CITY OF WEST DES MOINES
CITY COUNCIL MEETING COMMUNICATION

ITEM: Hawthorne Centre East Patio – 9500 University Avenue – Install Patio on the East Side of the Building – Hawthorne Plaza LLC – MML1-003448-2017

RESOLUTION: **Approval of Minor Modification Level 1**

CITY OF WEST DES MOINES
PLAN AND ZONING COMMISSION COMMUNICATION

ATTACHMENT C

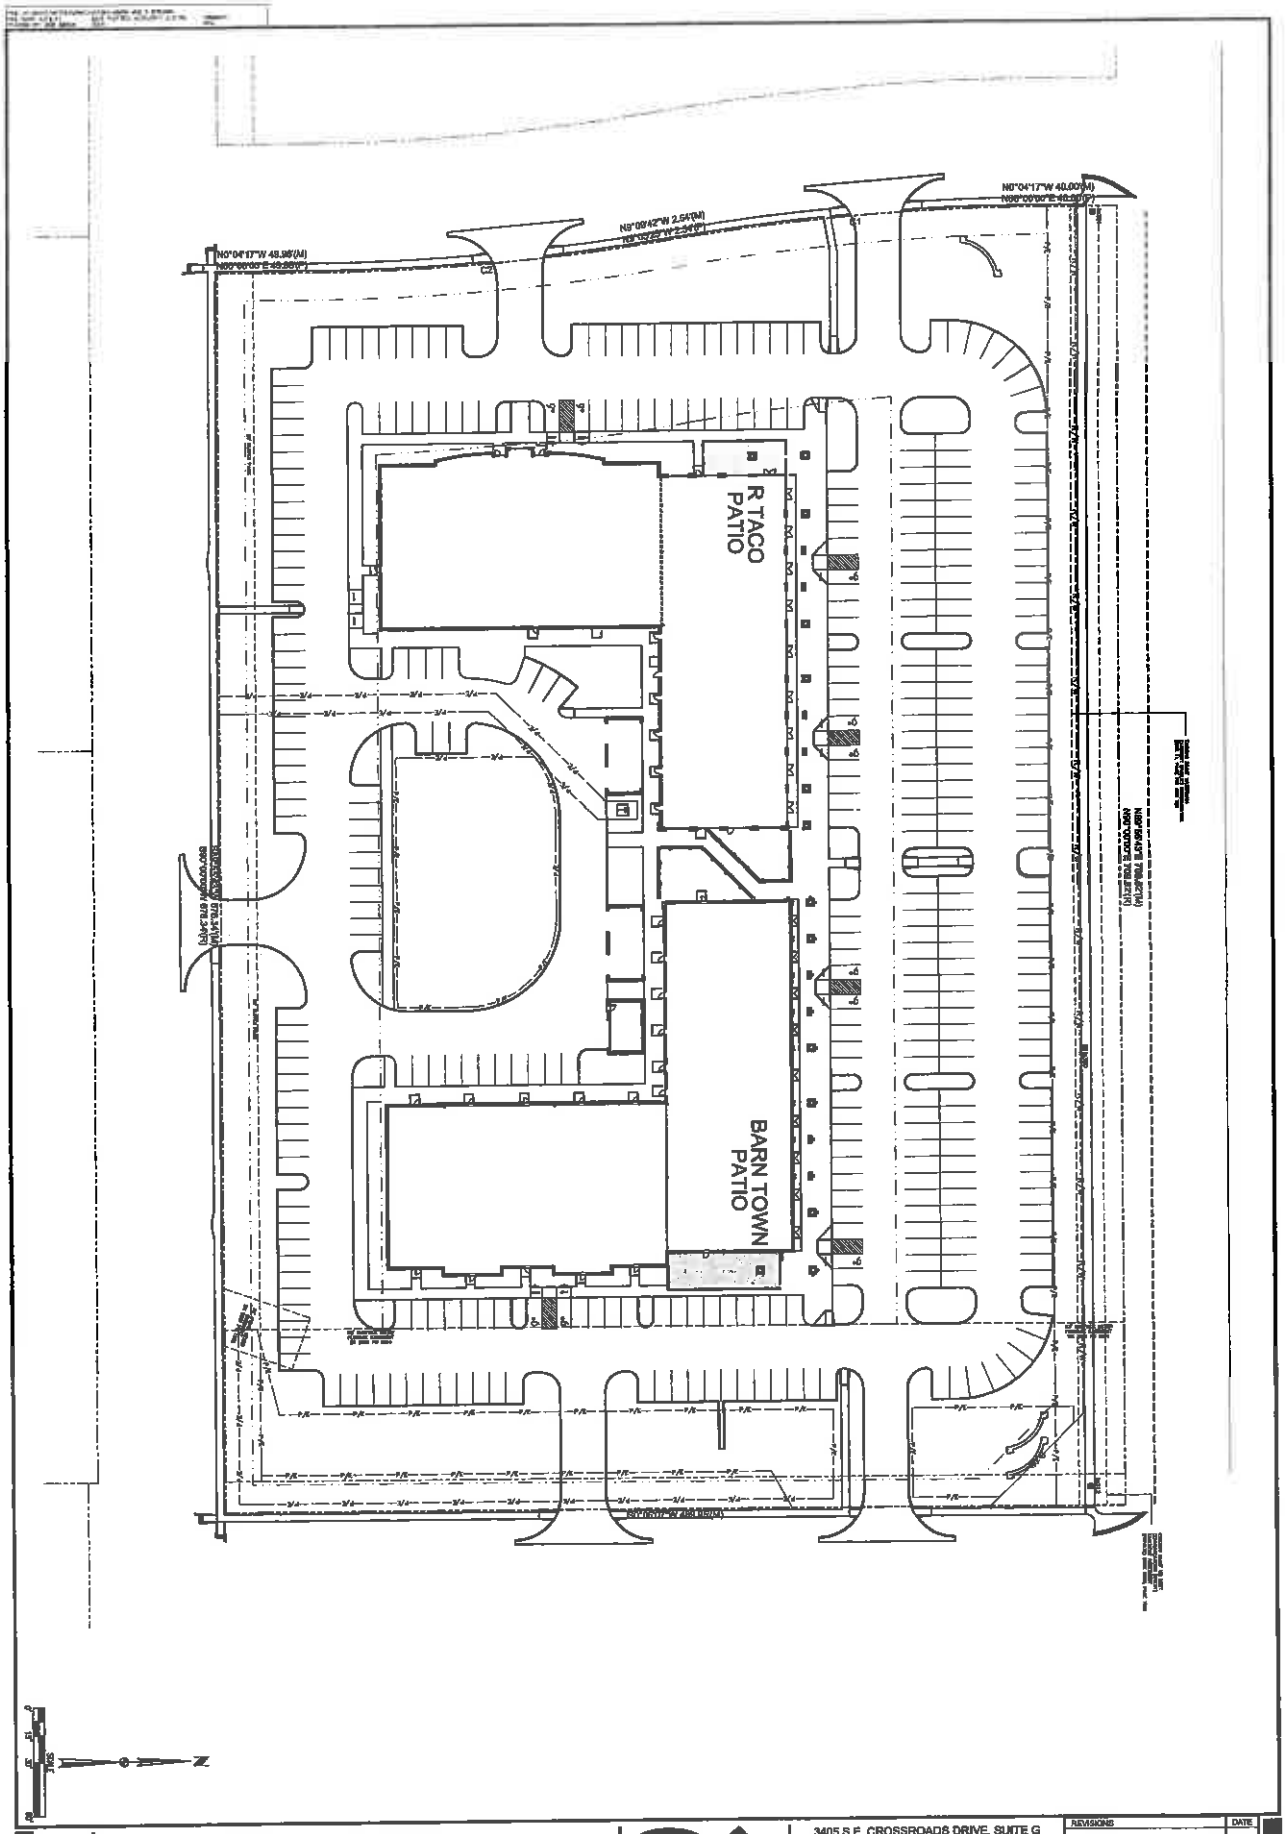
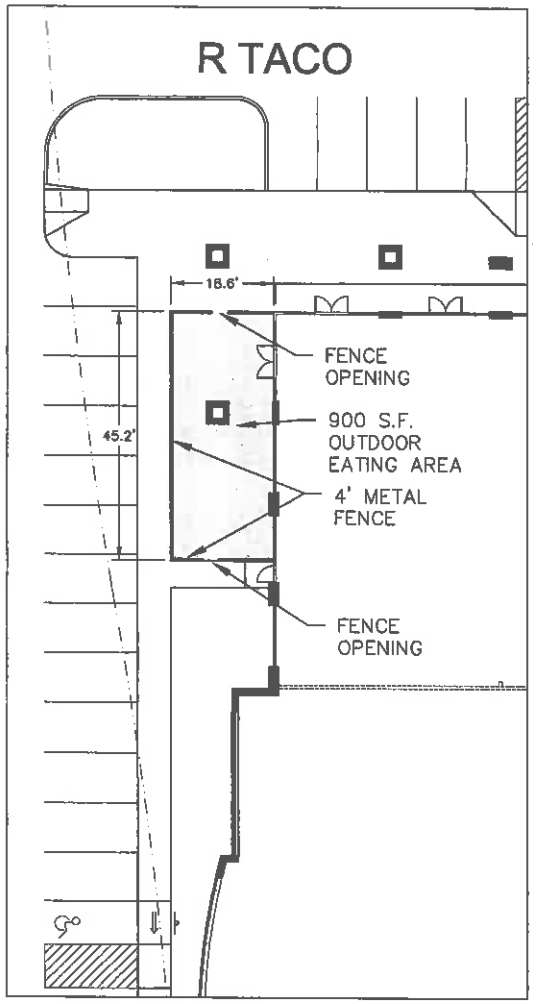
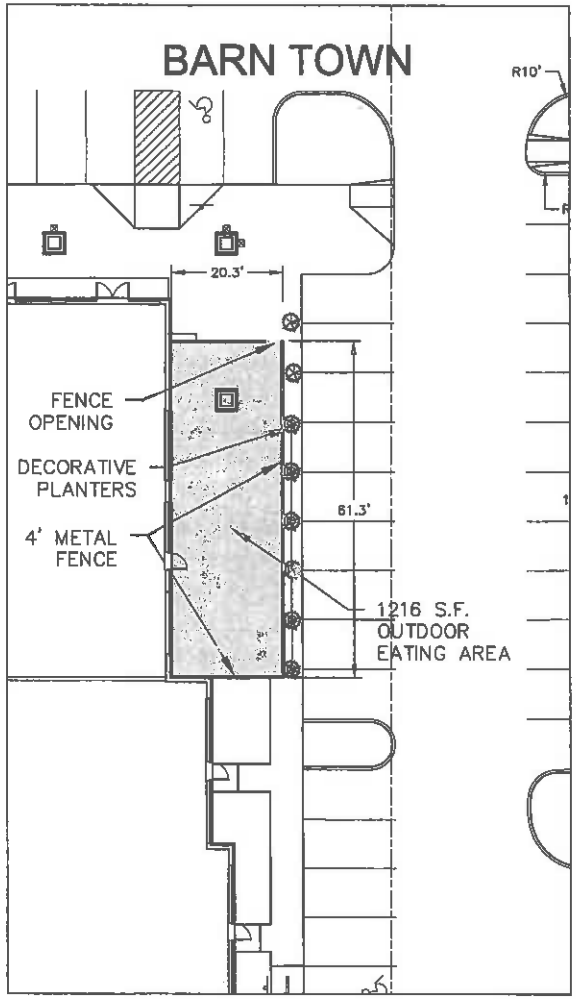
OUTSTANDING ISSUE: There is **one outstanding issue** with regard to the applicant's request to encroach into the six foot sidewalk with a patio. The Plan and Zoning Commission approved the patio with a condition of approval to maintain the six foot sidewalk, allowing for two feet of vehicle overhang over the sidewalk and four feet of sidewalk for pedestrians. The applicant would like the City Council to consider the request to allow the patio to encroach into the sidewalk and place planters outside of the patio for aesthetic reasons and to help buffer the patio enclosure from the vehicle parking.

In concert with the Plan & Zoning Commission's recommendation, staff stands by its recommendation that the six foot sidewalk be maintained. It is important that a commercial building with multiple tenants provides a safe way for pedestrians to travel between the different businesses without being forced to walk thru the parking lot because there is no sidewalk connection along the storefronts. The examples submitted by the applicant include the Drury Inn where there is no sidewalk along one side of the building, although it is a sole business building. The bank and multi-tenant building examples have different parking lot configurations, but do provide a continuous walk connection along the multiple storefronts. And the West Glen patio example is a good illustration for why staff recommends the sidewalk be maintained at six feet as the Council will notice that the property owner has placed curb stops to keep vehicles from overhanging the sidewalk. The curb stops are only allowed by City Council approval and are not typically recommended by staff; staff did not research the approval status of the use of the curb stopes at this location. The Council will note that the curb stops are not permanent and have shifted positions. Also, staff has not checked to see of the required 17 feet of stall depth is being maintained.

Patio adjacent to head-in parking: As part of the minor modification, another patio is proposed for the west side of the companion building on the site. That patio is meeting staff's recommendation to maintain the six foot sidewalk along the west side of the building adjacent to the head-in parking on that side. That patio has been administratively approved. The east building patio is subject to review by the Plan & Zoning Commission and City Council as the tenant wishes to extend the patio closer to the parking than staff's recommendation.

During the review of the patios proposed on the east and west sides of the Hawthorne Center building, staff recommended that the patio extend out from the building no closer than six feet from the back of the curb to the adjacent head-in parking. The sidewalk along the building is required to be six feet to allow for a four foot sidewalk and two feet of vehicle overhang from the head-in parking adjacent to the building (Title 9, Chapter 16, Section 6-F-2 provides for when the front of a parking stall abuts a sidewalk, the minimum width of the sidewalk shall be six feet). This building has at least a six foot sidewalk around the building and has areas that are larger for patio space. The Commission should notice that the parking adjacent to the building in the subject area is head-in parking.

The tenant has proposed a patio that is closer to the head-in parking leaving two feet for vehicle overhang and approximately two feet additional space between the parking and the patio. The tenant proposes to place planters in the approximately two foot area to discourage pedestrian access across the patio frontage. While an able-bodied individual may be able to maneuver between the bollards, a wheelchair bound individual would not and would be forced to turn – around and use a non-defined pathway within the parking lot. Staff would note that the proposed patio is 20' deep: a 2-foot reduction would not render the patio unuseable.

1. The applicant insuring that a minimum six foot sidewalk between the back of curb for the head-in parking on the east side of the building at 9500 University Avenue and the patio boundary is maintained at all times.
2. Providing final minor modification drawings which reflect such prior to installation of the patio.

BARN TOWN

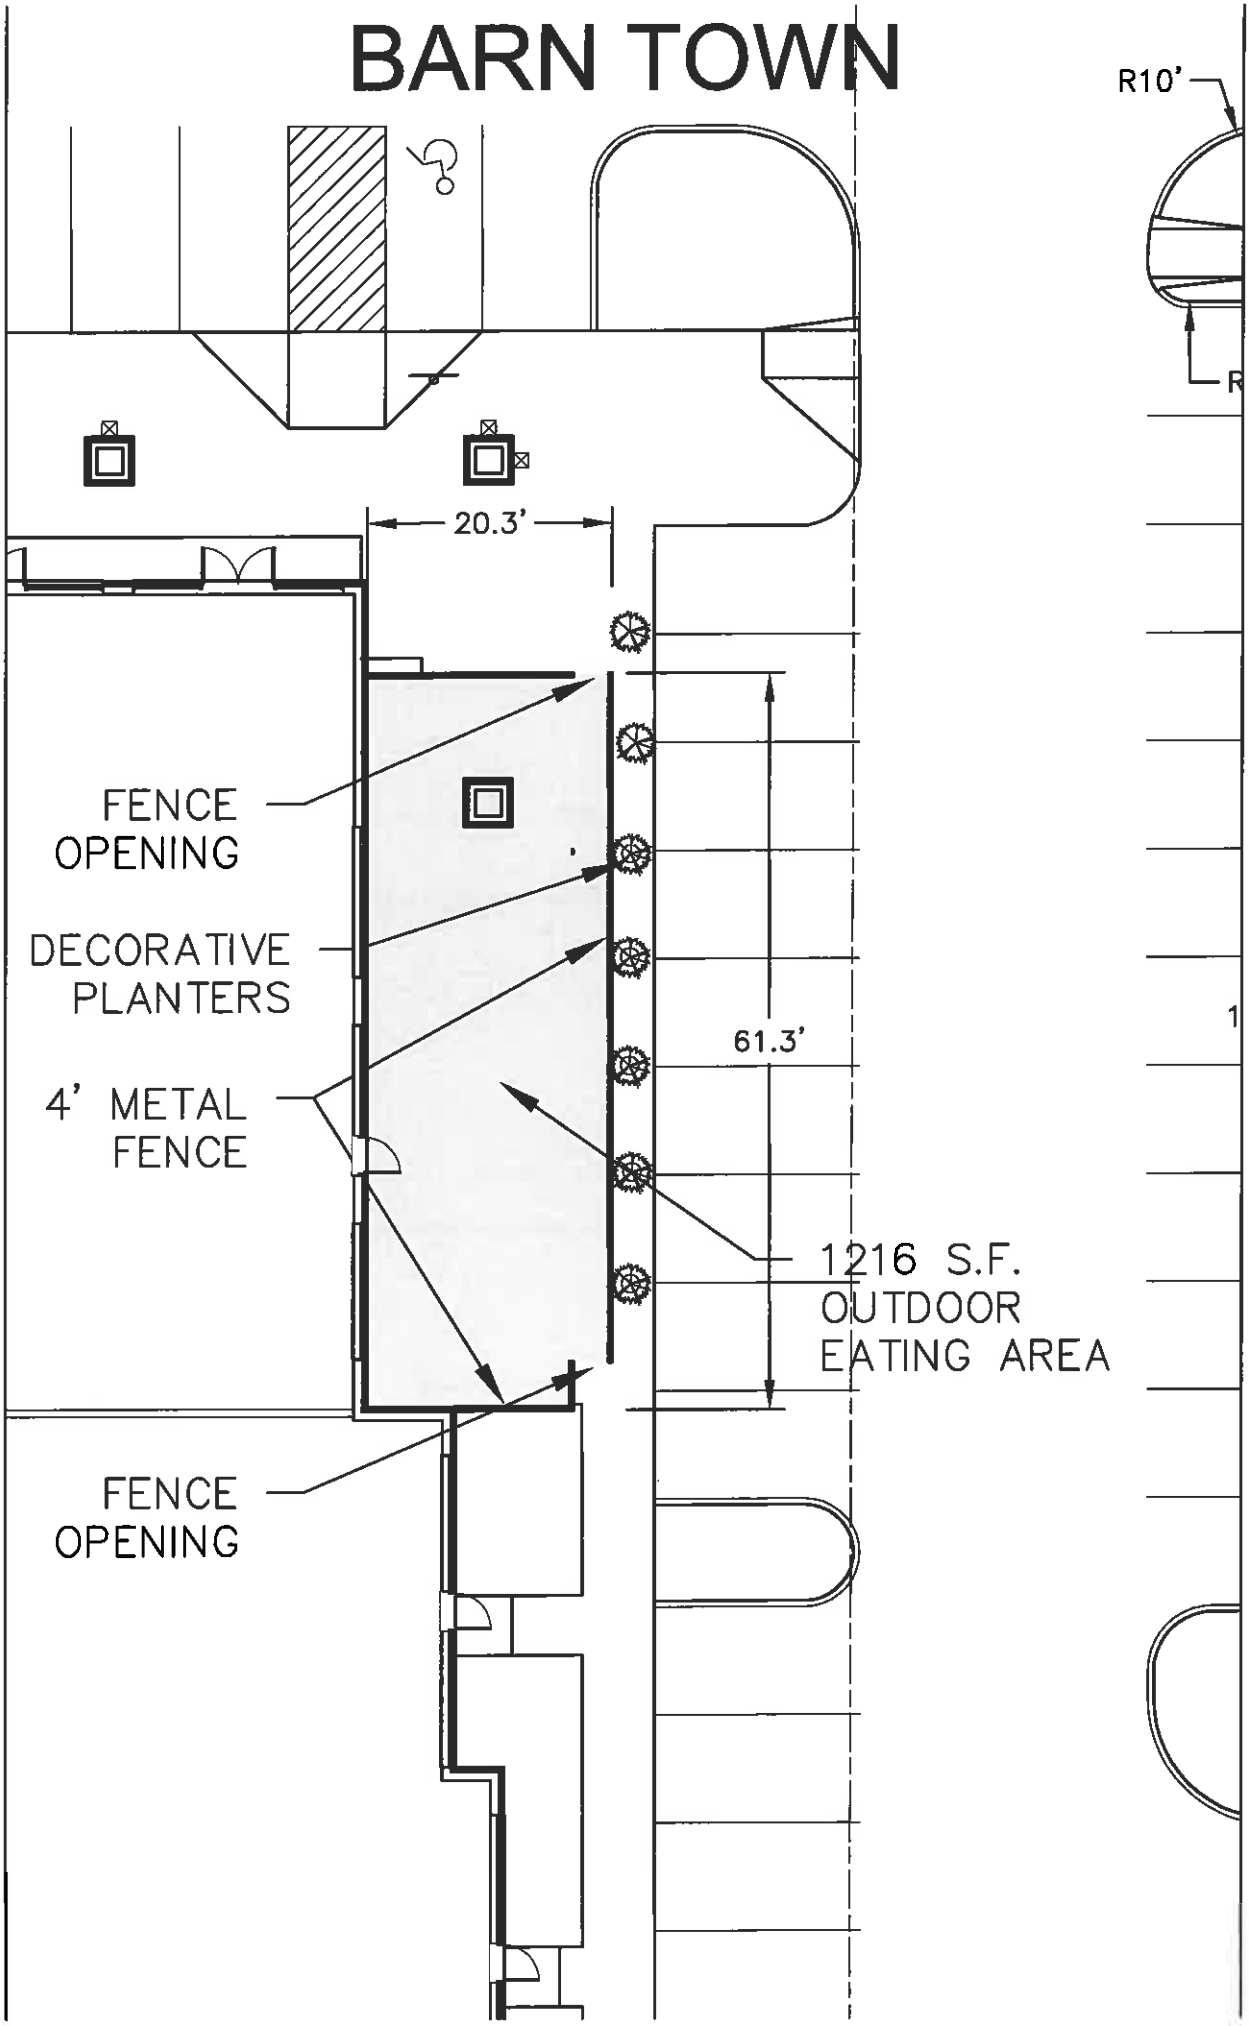
Barn Town is requesting that the fenced outdoor patio area be extended to within 4' of the head-in parking. We understand that for the area between the curb and fence to function as a sidewalk it needs to be a minimum of 6'. However, we are requesting that this area no longer be regarded as a sidewalk, which is why we are actually proposing a width of 3.5' and planters placed to make that clear to all. (the planters will also enhance the aesthetics of the patio space).

We also acknowledge that occasionally a pedestrian traveling from the north of the building to the east side (or vise-versa) would have to step into the parking lot to do so if they chose not to pass through the patio, which they could do. But to put things in perspective, the vast majority of patrons of Hawthorne Centre, like most other such facilities, have to cross though parking lot to get to the buildings. This is not a dangerous situation.

Also included is a patio plan showing the south opening in the fence.

1. The applicant insuring that a minimum six foot sidewalk between the back of curb for the head-in parking on the east side of the building at 9500 University Avenue and the patio boundary is maintained at all times.
2. Providing final minor modification drawings which reflect such prior to installation of the patio.
